Re: Feasibility Study Comments - American Chemical Services Site -
Griffith, Indiana

**ATTACHMENT 1
FEASIBILITY STUDY REVIEW COMMENTS
AMERICAN CHEMICAL SERVICES SITE
GRIFFITH, INDIANA**

FIGURE 6

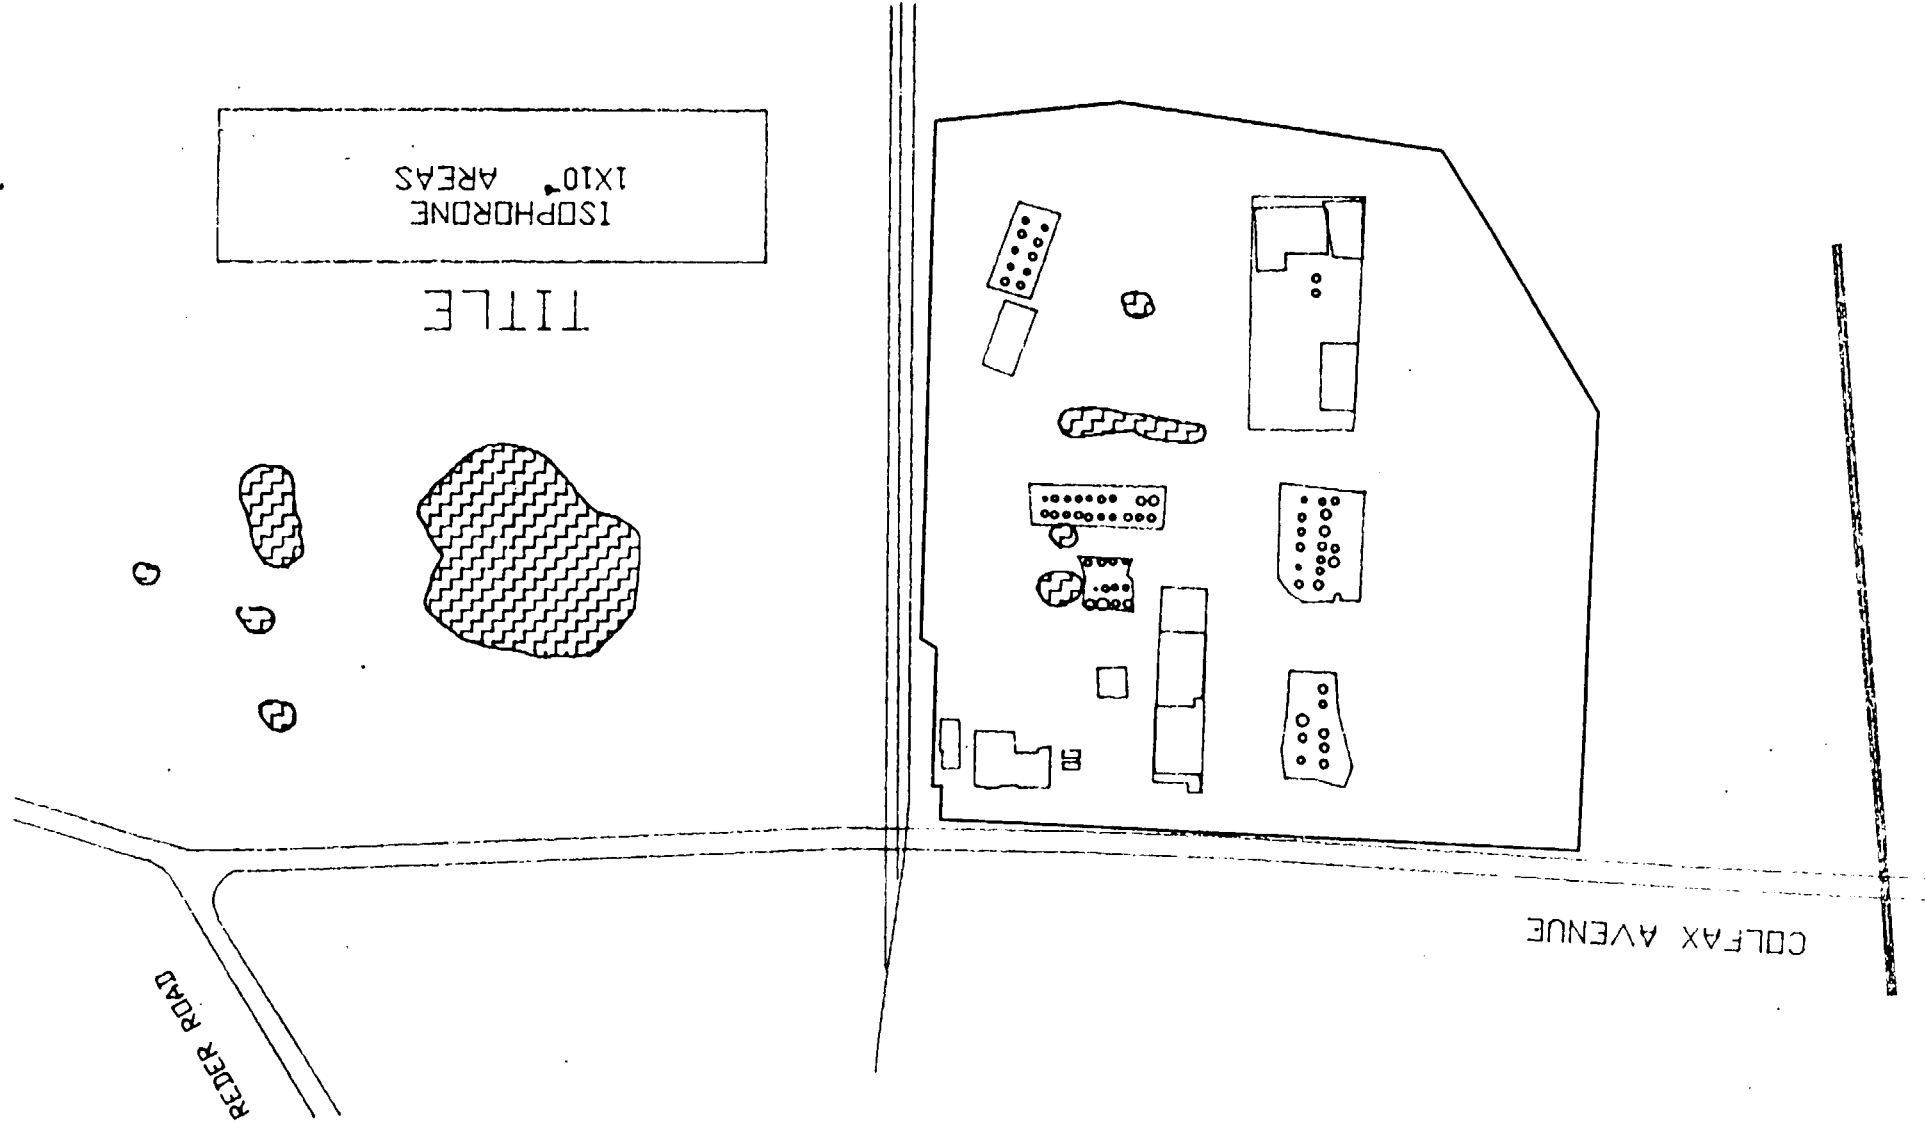
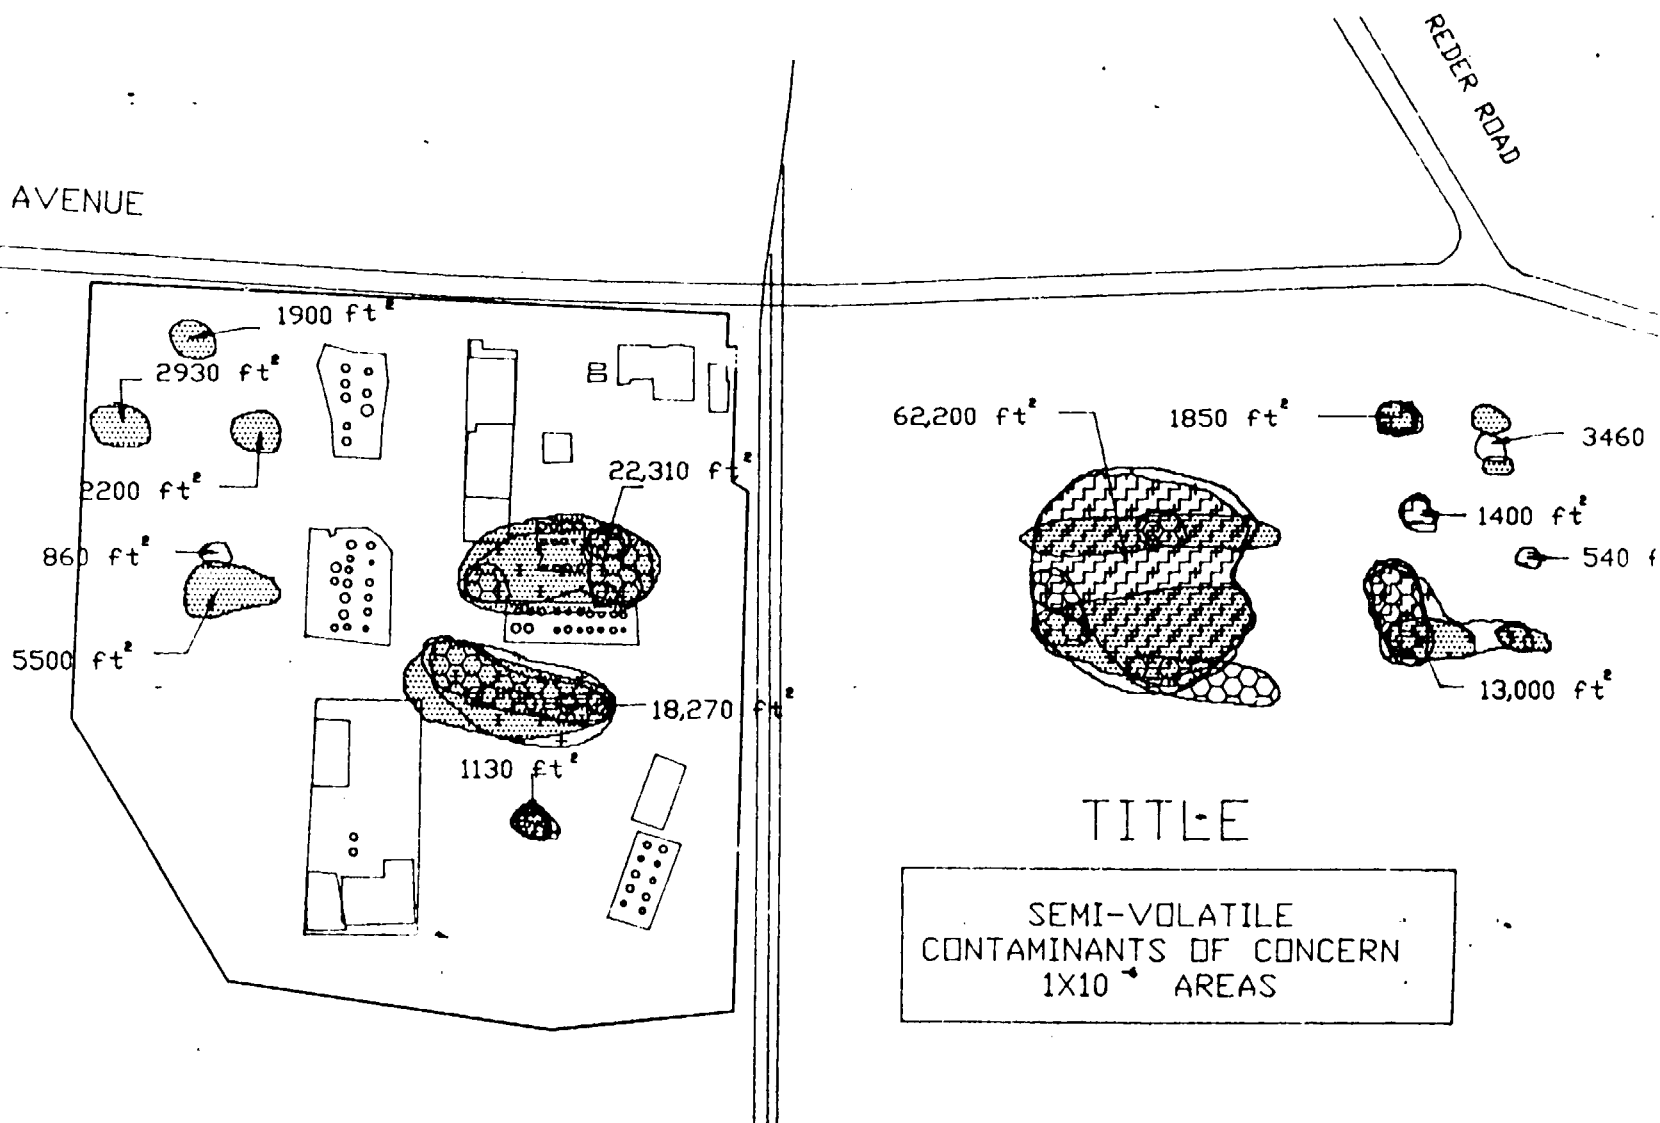
In general the cost estimates seem reasonable and probably fall within the -30%, +50% FS cost estimate guideline. However, in the following comments you will find requests for the basis of the cost estimates. It was expected that more backup information (cost assumptions, vendor quotes, etc.) would have been provided. This backup information could be provided on a notes page attached to each alternative and would allow the reviewer to feel more comfortable about the cost estimate for each line item. Attachment 5 is an example of the amount of detail which is expected for the cost estimates.
